Range OCS	Model MAGIC	N° T.I. 18_2023
Serial Number 9023MGC0013583	Subject Release software V. 1.11.6

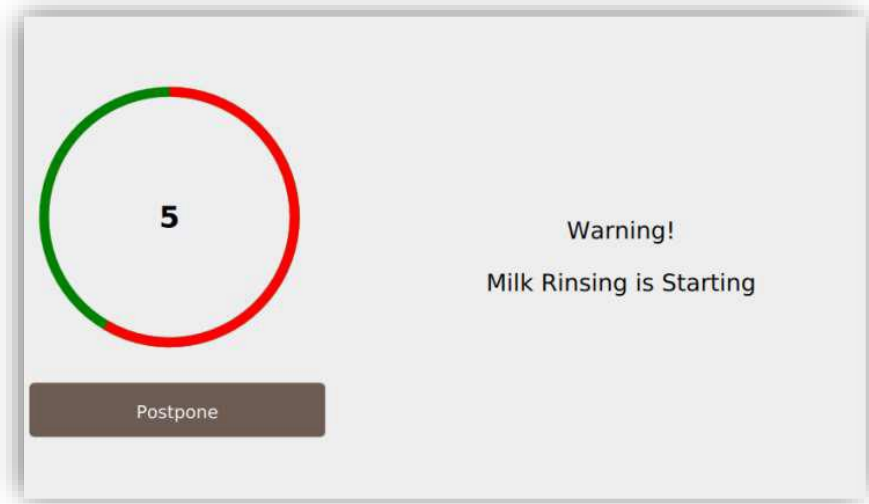
- Added possibility of postponing rinsing of the milk circuit.

When the machine finishes dispensing a milk-based drink, a 5-minute timer starts, and if no other drink with milk is dispensed in these 5 minutes, the machine automatically rinses the cappuccinatore.

Ten seconds before starting the rinse, the machine shows a pop-up on the display with a countdown, and the «POSTPONE» button, with which the user can postpone the rinse for 5 minutes. A maximum of two postponements are allowed, then the rinsing is carried out.
